CL 136 Link Training – Update Request Behavior

IEEE P802.3cd Task Force

Berlin, July 2017

Figure 136-9—Coefficient update state diagram

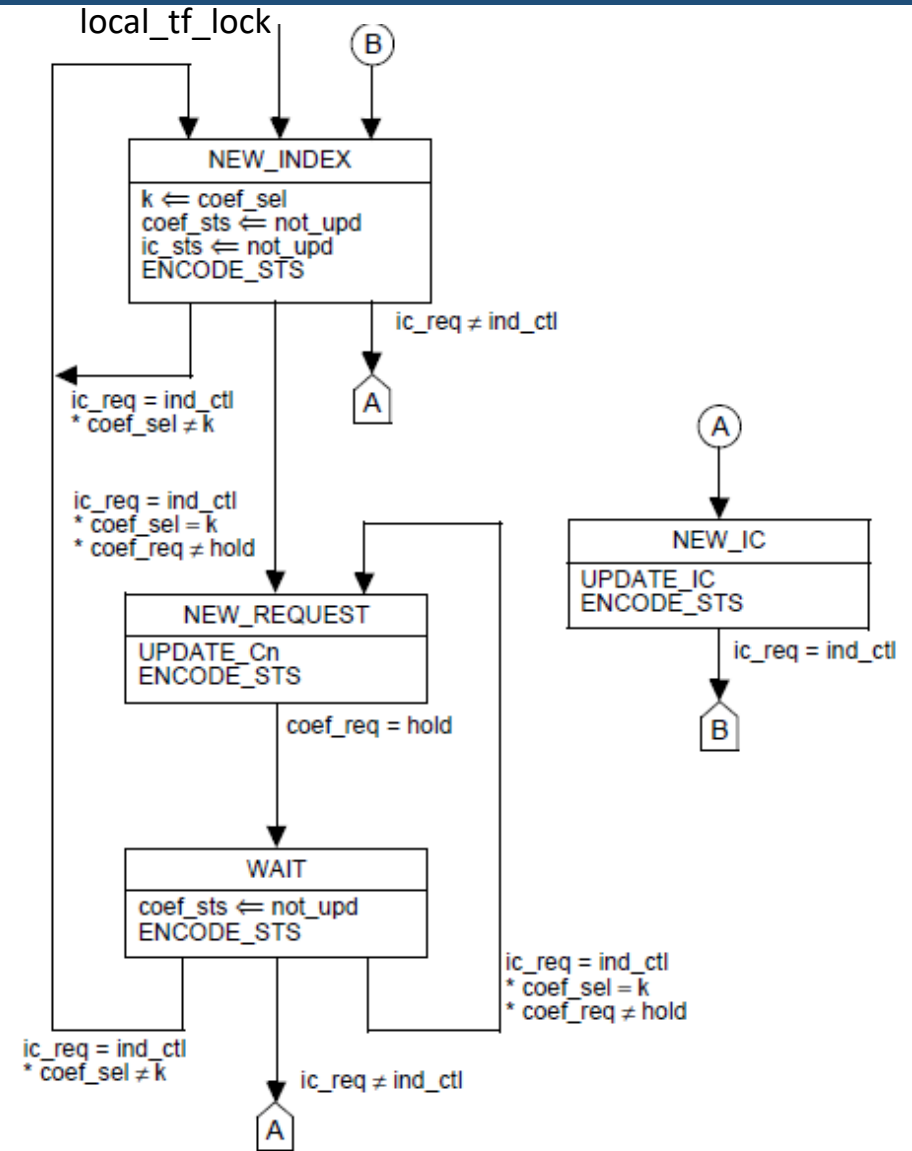
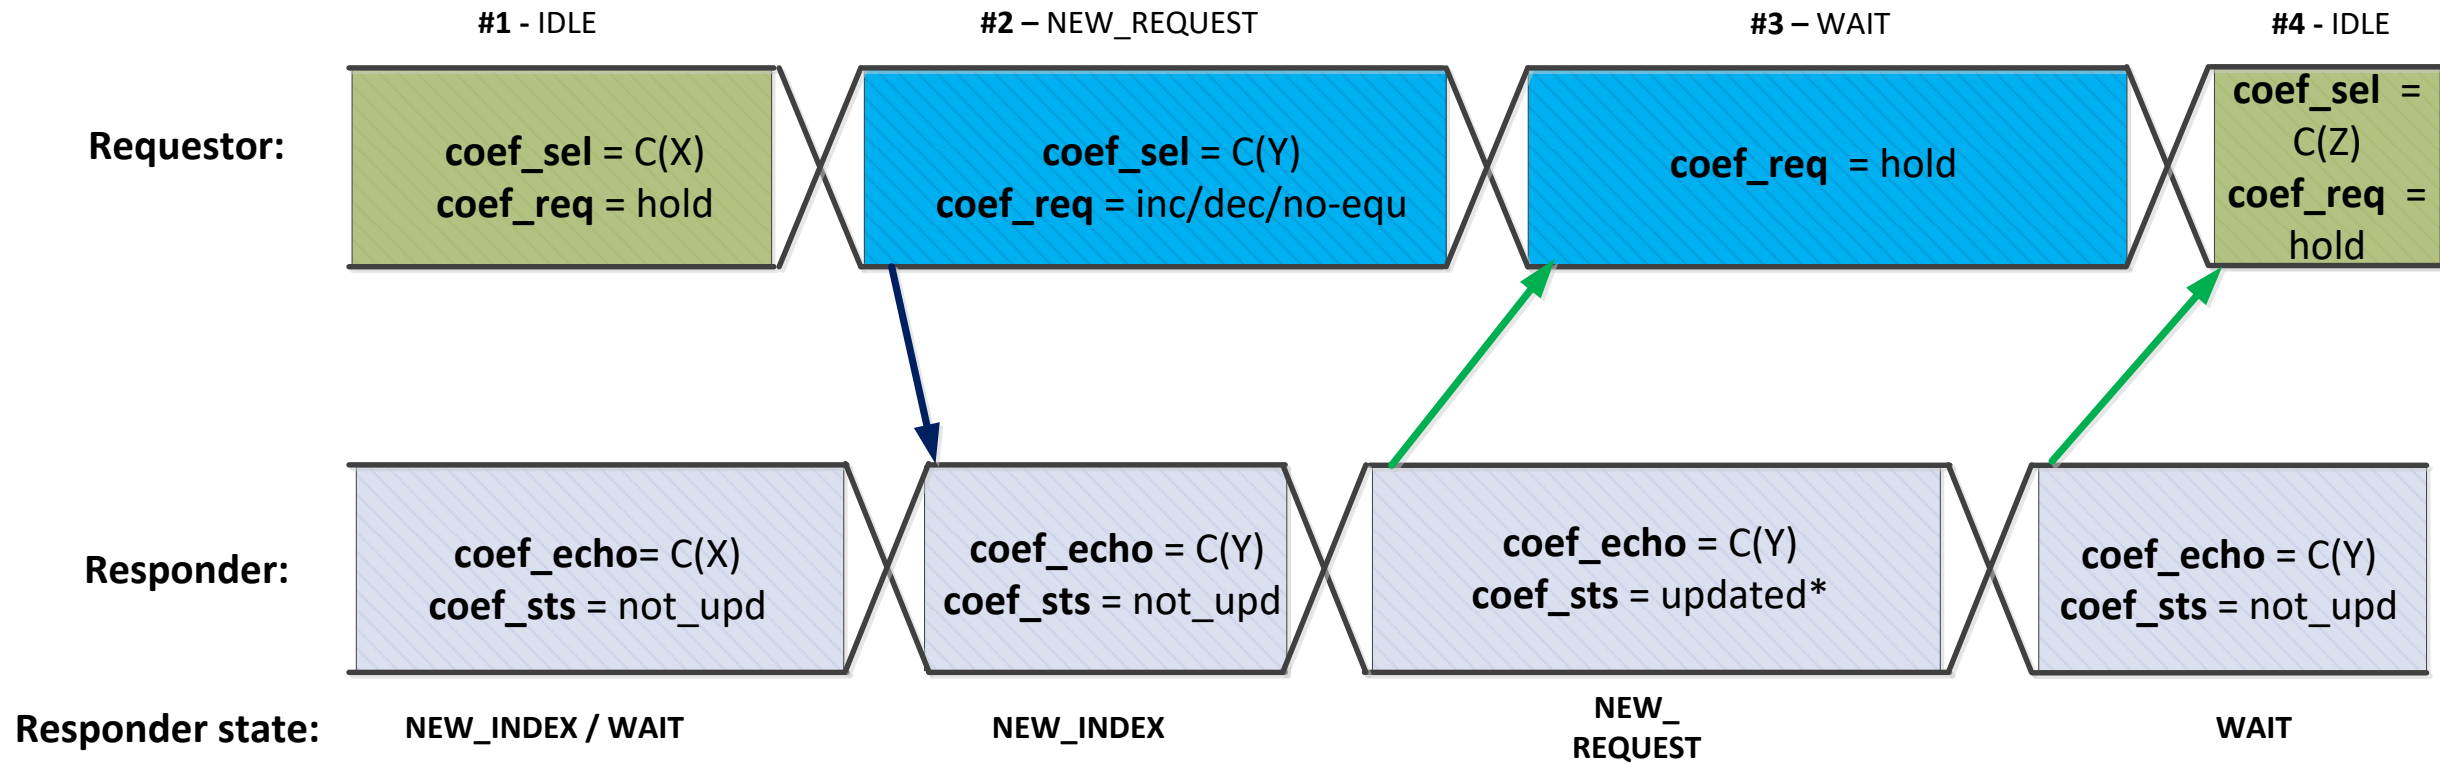
- Transition from NEW_INDEX/WAIT to NEW_REQUEST
 - Upon individual request reception.
 - Additional “round” of NEW_INDEX will take place before the transition, in case the local coefficient index (k) is not set to the requested *coef_sel* value.
- Transition from NEW_REQUEST to WAIT
 - Upon reception of “hold” coefficient request.
 - Initiating New request, can’t be performed without receiving “hold” request, regardless to *coef_sel* value.
- No transition between NEW_REQUEST and NEW_IC states.
- There is an assumption that the requestor follows a sequence of operations that matches the responder state machine transitions.

Requestor behavior for coefficient request

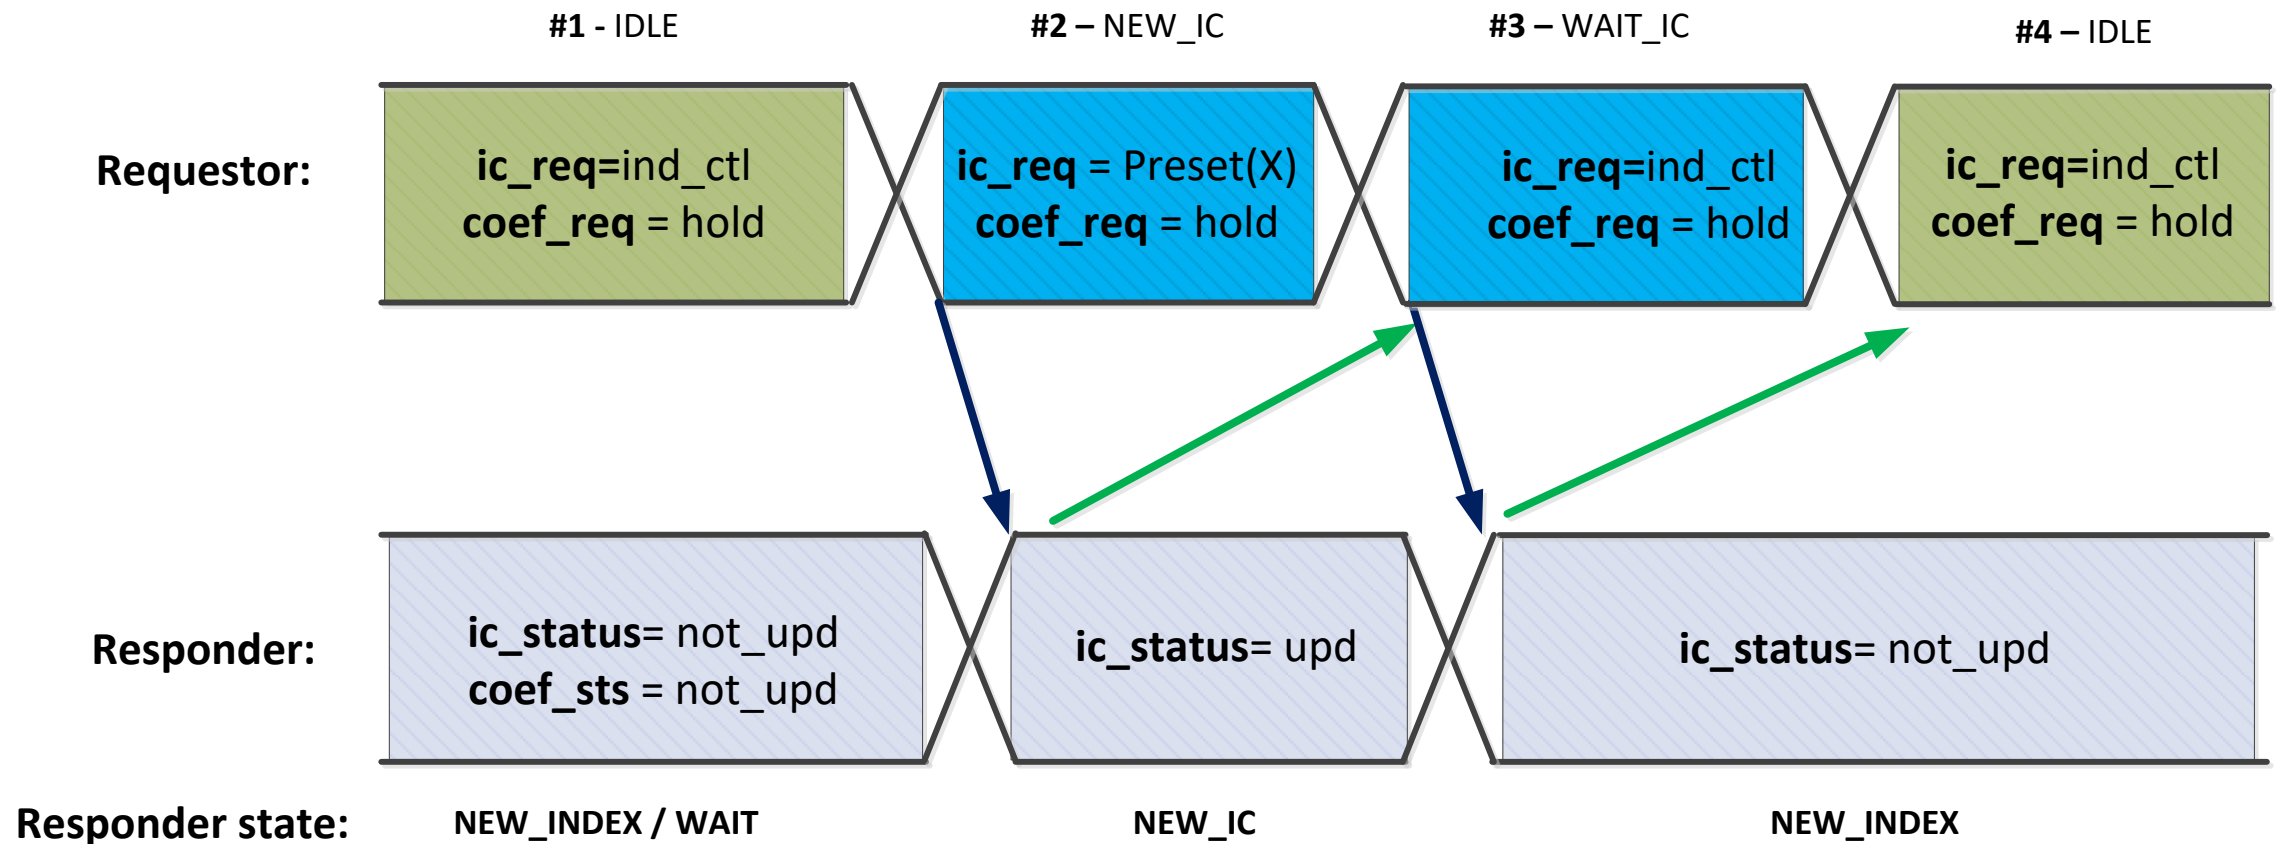
Proposal: Add description for the requestor behavior

- A request to change a coefficient is made by using the following procedure:
 - Wait until the received coefficient status bits (136.8.11.3.7) indicate "not updated".

- Set the coefficient select bits (136.8.11.2.3) and coefficient request bits (136.8.11.2.4) to the desired values. This may be done in one step (both fields updated in the same training frame) or sequentially

- Wait until the received coefficient status bits (136.8.11.3.7) do not indicate "not updated".
 - Set the coefficient request bits (136.8.11.2.4) to "hold".

- A request to change the initial condition is made by using the following procedure:
 - If any other request was previously sent, wait until both the initial condition status bits (136.8.11.3.4) and the coefficient status bits (136.8.11.3.7) indicate "not_updated".

- Set the initial condition request bits (136.8.11.2.1) to the desired pre-defined transmitter equalizer configuration (preset).
 - Wait until the initial condition status bits (136.8.11.3.4) indicate "updated".

- Set the initial condition request bits (136.8.11.2.1) to individual coefficient control, and set the coefficient request bits (136.8.11.2.4) to "hold".

- A procedure must be completed before initiating a new individual coefficient update request or initial condition update request.

Figure 136-9—Coefficient update state diagram

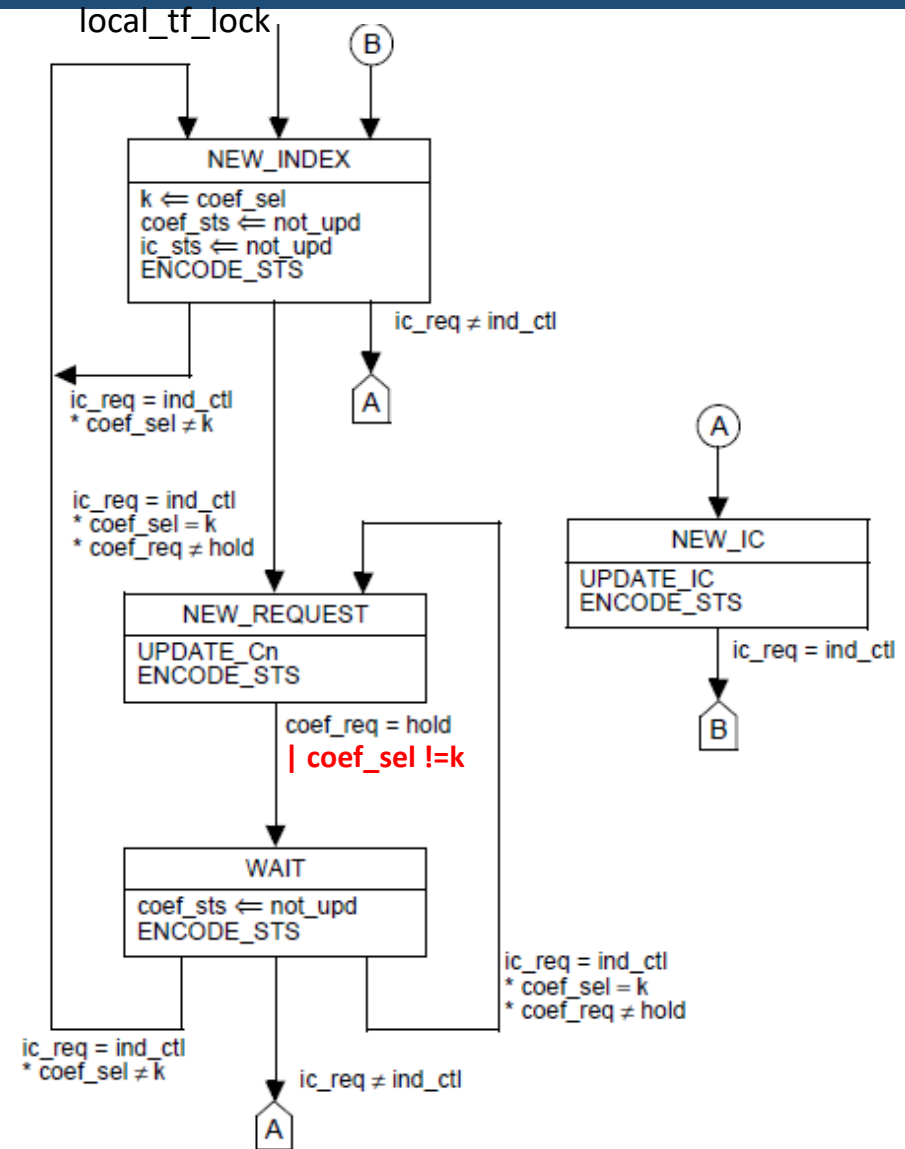
- Remove the need to send “hold” on subsequent individual coefficient requests of different coefficients.
 - Useful when all the coefficients have to be updated.
- The requestor will identify a response to the requested coefficient according to the received coefficient select echo.
- Modify the condition for a transition to WAIT to:
 $\text{coef_req} = \text{hold} \mid \text{coef_sel} \neq k$

- A request to change a coefficient is made by using the following procedure:
 - Set the coefficient select bits (136.8.11.2.3) and coefficient request bits (136.8.11.2.4) to the desired values. This may be done in one step (both fields updated in the same training frame) or sequentially

- Wait until the received coefficient status bits (136.8.11.3.7) do not indicate "not updated" and the coefficient select echo bits (136.8.11.3.6) indicates the requested coefficient select value.

- If the subsequent request updates the same coefficient or requests a new initial condition, set the coefficient request bits (136.8.11.2.4) to "hold" and wait until the received coefficient status bits (136.8.11.3.7) indicate "not updated".

- A request to change the initial condition is made by using the following procedure:
 - Set the initial condition request bits (136.8.11.2.1) to the desired pre-defined transmitter equalizer configuration (preset).

- Wait until the initial condition status bits (136.8.11.3.4) indicate "updated".
 - Set the initial condition request bits (136.8.11.2.1) to individual coefficient control, and set the coefficient request bits (136.8.11.2.4) to "hold".

- wait until both the initial condition status bits (136.8.11.3.4) and the coefficient status bits (136.8.11.3.7) indicate "not_updated".
- A procedure must be completed before initiating a new individual coefficient update request or initial condition update request.
